# ACTION TRANSMITTAL No. 2021-57

| DATE:                  | November 24, 2021   |
|------------------------|---|
| SUBJECT:               | Streamlined 2022-2025 TIP amendment for Woodbury: HSIP Project Expansion  |

SP # 192-108-028

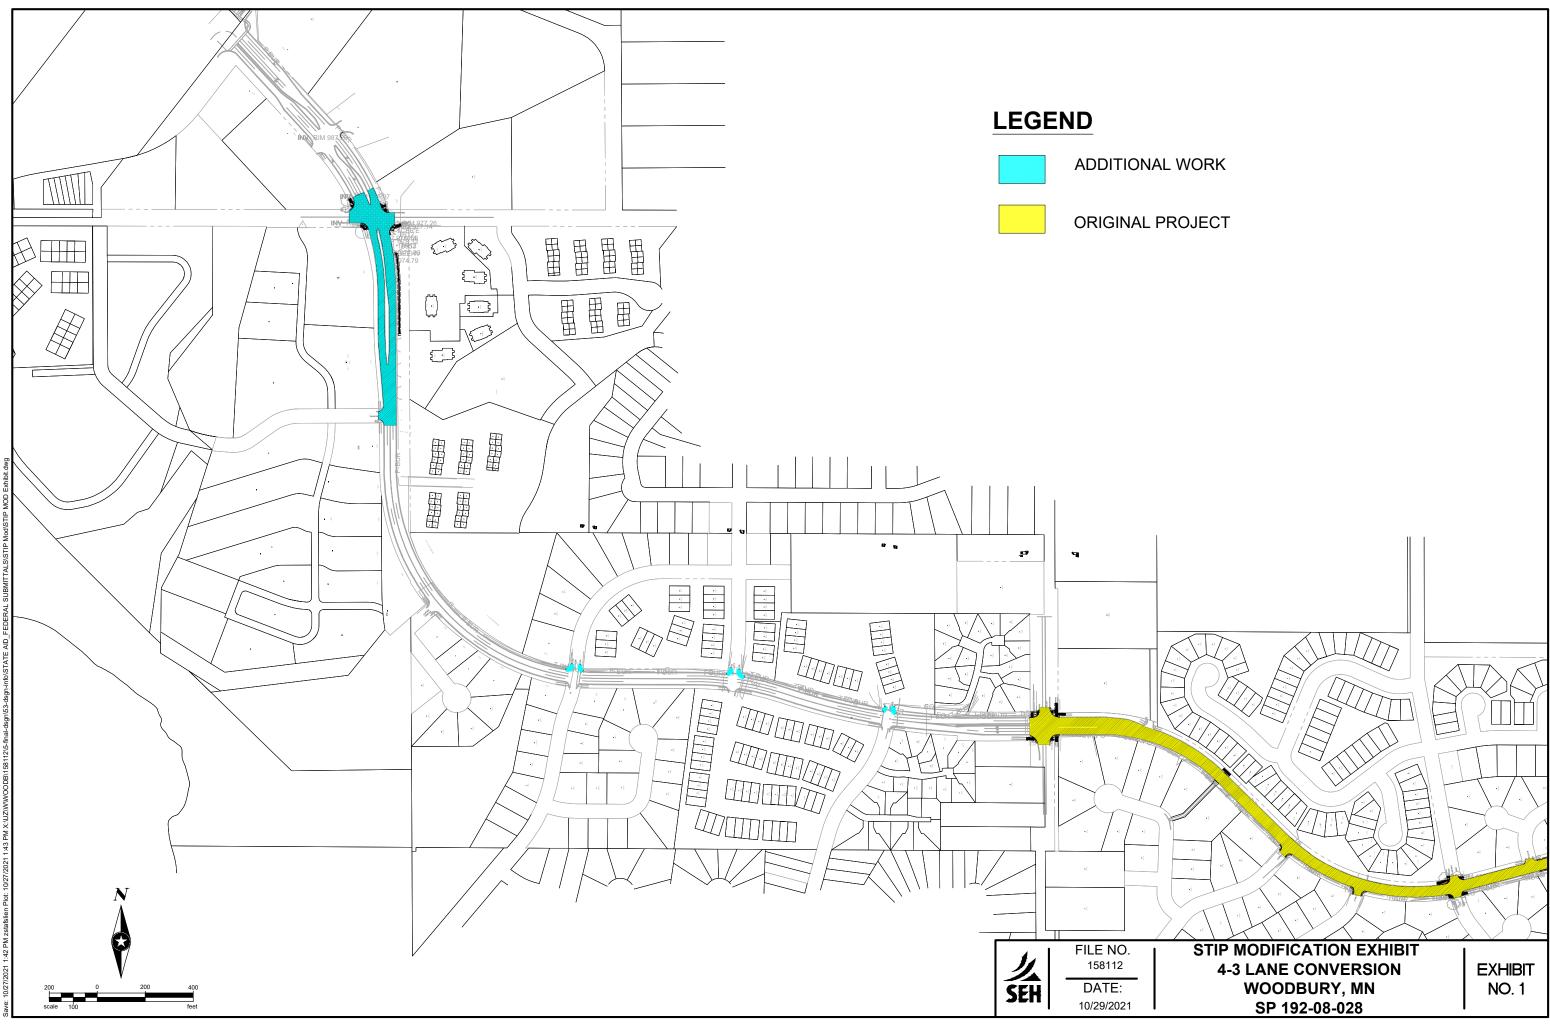
Intersection improvements at Lake Road and Courtly Avenue including improvements to pedestrian ramps, signals, and full pavement replacement. Drain tile added on north side of Lake Rd east of Courtly Ave due to drainage issue. Mill and overlay on Lake Road from east of Courtly Rd to Tahoe Rd. Curb improvements on north side of Lake Rd at Jordan Dr, Cornelia Tr, and Lake Terrace W for future trail project. Reason for adding work is due to pavement condition, safety issues, and future trail project.

Work will be funded by Municipal State Aid Roadway Construction Fund.
